UNITED STATES PATENT AND TRADEMARK OFFICE

10/065,772

Office Action Summary

DETAILED ACTION

Fig. 2

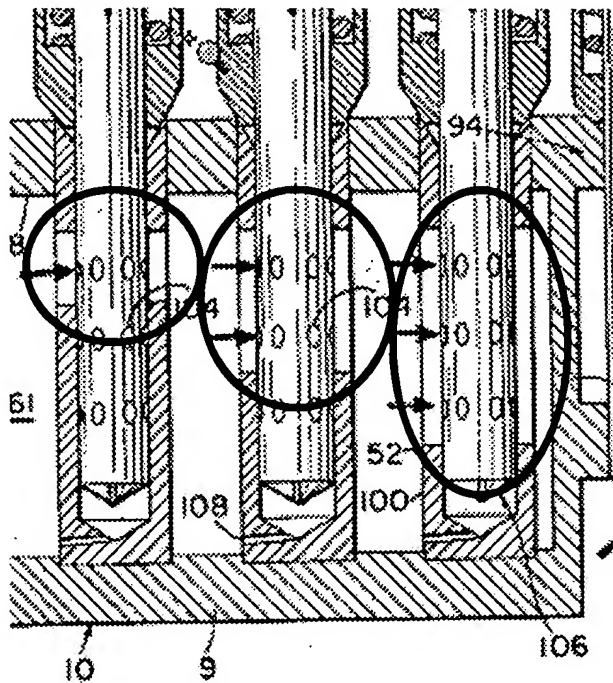
Further, Patterson Fig 2. clearly shows a means of controlling coolant flow separate from the means of controlling coolant flow for each individual main coolant flow channel as indicated by the circles imposed on said Figure 2 below.

While patent drawings are not drawn to scale, relationships clearly shown in the drawings of a reference patent cannot be disregarded in determining the patentability of claims. See In re Mraz, 59 CCPA 866, 455 F.2d 1069, 173 USPQ 25 (1972).
